Access Compliance Report

Public Rights-of-Way

(Curb Ramps)

Intersection ID: 30464	Main Street: BUBBLING_BROOK_CT	Cross Street: PLANTERS_ROW_DR	Location: S
ADA ID: 21F7E56B3560	Ramp Type: PerpDiag	Initial Pass/Fail: Fail	Overall Compliance: No
Severity Score: 33.75			
Codes/Mitigation Info/Possible Solution		Field Measurements/Component Compliance

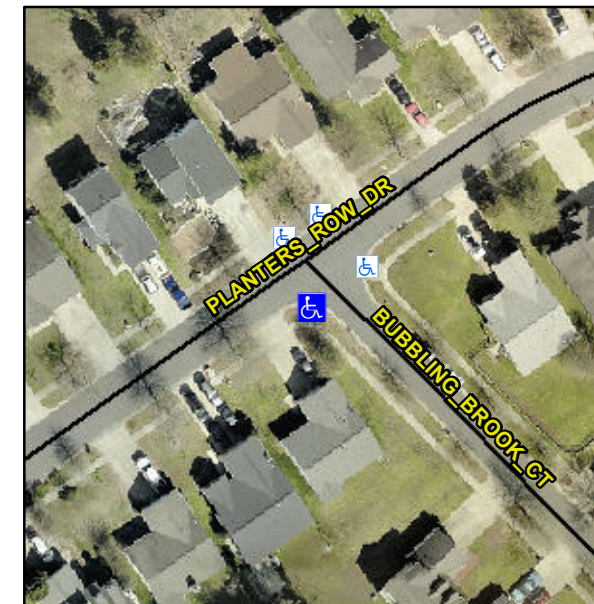
Not Found, R304.5.1, R304.2.2

Compliance	Description	Data	Compliance	Description	Data
N/A	Ramp Length (in)	84.0	No	Ramp Slope (%)	12.3
No	Ramp Width (in)	46.5	Yes	Ramp XSlope (%)	0.0
N/A	Flare Type LT	N/A	N/A	Flare Type RT	N/A
N/A	Flare Slope LT (%)	N/A	N/A	Flare Slope RT (%)	N/A
N/A	Flare Traversable LT?	N/A	N/A	Flare Traversable RT?	N/A
N/A	Landing Length (in)	N/A	N/A	DWS Provided?	N/A
N/A	Landing Width (in)	N/A	N/A	DWS Contrast?	N/A
N/A	Landing Slope (%)	N/A	N/A	DWS Length (in)	N/A
N/A	Landing X Slope (%)	N/A	N/A	DWS Full Width?	N/A
N/A	Landing Curb? (Y/N)	N/A	N/A	DWS Offset (in)	N/A
N/A	Shared Landing?	N/A			
N/A	Gutter Ponding?	N/A	N/A	Gutter Slope (%)	N/A
N/A	Gutter Lip Ht (in)	N/A	N/A	Gutter X Slope (%)	N/A
N/A	Painted X Walk1?	No	N/A	Painted X Walk2?	No
	X Walk 1 Direction	To NE		X Walk 2 Direction	To NW
N/A	X Walk 1 Width (in)	N/A	N/A	X Walk 2 Width (in)	N/A
	X Walk 1 Slope (%)	0.4		X Walk 2 Slope (%)	0.8
	X Walk 1 X Slope (%)	0.9		X Walk 2 X Slope (%)	0.4

Remove & Replace Curb Ramp With Two New Directional Ramps or Equivalent.
